ADDENDUM #1

ITB# 1827-23

East Hartford Middle School Roof Replacement

**Test Cut #2 – Roof Section Building H
4 Ply 5 1/2 “ yellow fiberglass insulation paper mounted to gypsum
deck. Total thickness of 6”**

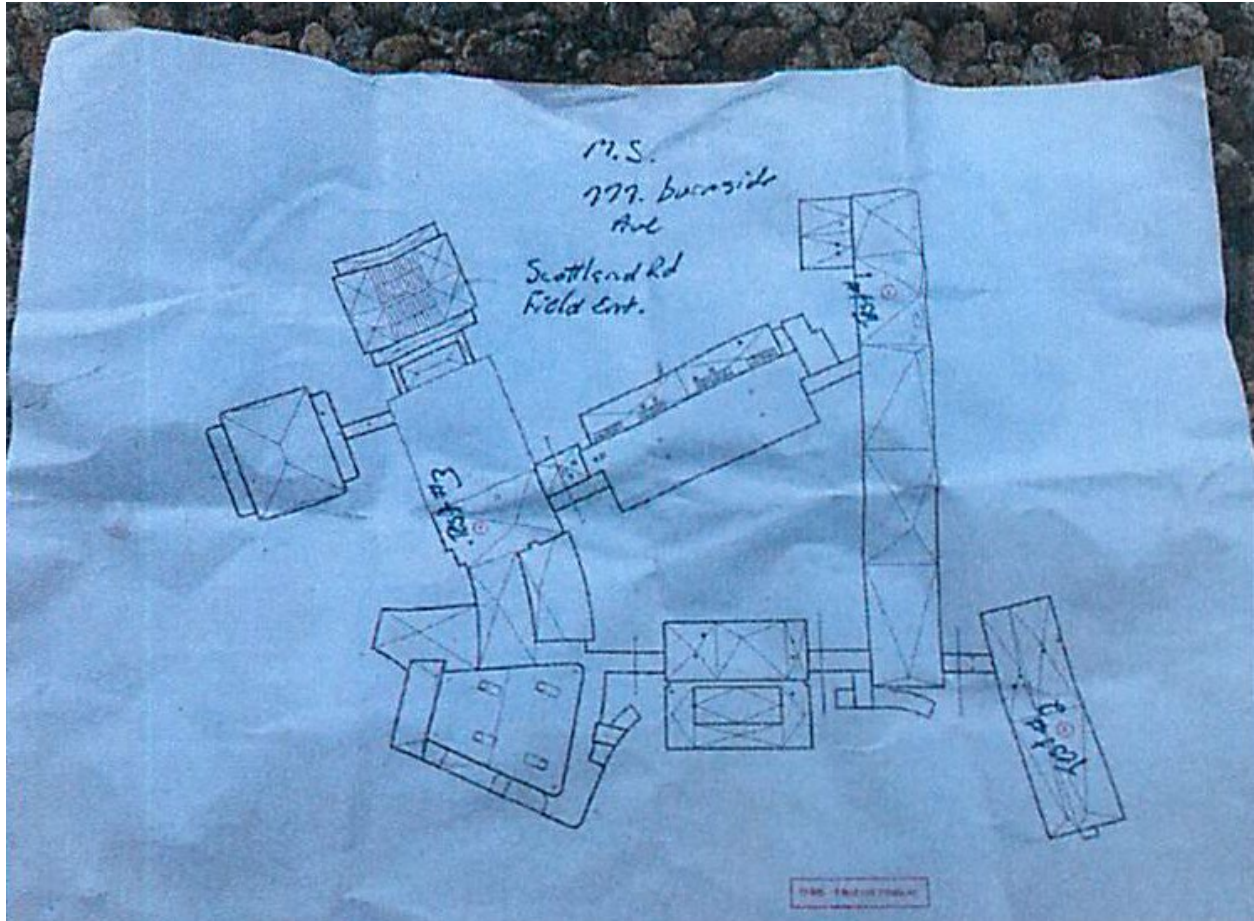
1. **Question:** Test cuts are needed to figure removal labor costs and dumpsters. Please provide that information or can we set up a day and time for the contractors to come back and perform test cuts?

The following pictures represent three separate roof cuts that were taken by a commercial roofing contractor in 2019:

Test Cut #1 – Roof Section Building B
4 Ply 4 1/2 " yellow fiberglass insulation paper mounted to gypsum deck. Total thickness of 5"

Test Cut #3 – Roof Section Bld. D by Cafeteria/Lobby
4 Ply 5 1/2 " yellow fiberglass insulation paper mounted to gypsum deck.
Total thickness of 6"

Answer: Please disregard the section of the sentence under General Notes #2 on the drawings referencing; "Perform Test Cuts at Each Roof Prior to the Bid" as contractors will not be allowed to take test cuts prior to the bid. However, we will share the results of test cuts that were taken of the Middle School roof in 2019. These test cuts (pictures and results are located near the end of this addendum) are a representative sampling and average of the overall roofing but should not be used as the sole source of determination. As other considerations must be also taken into account when determining the final costs for demolition of the existing roofing.
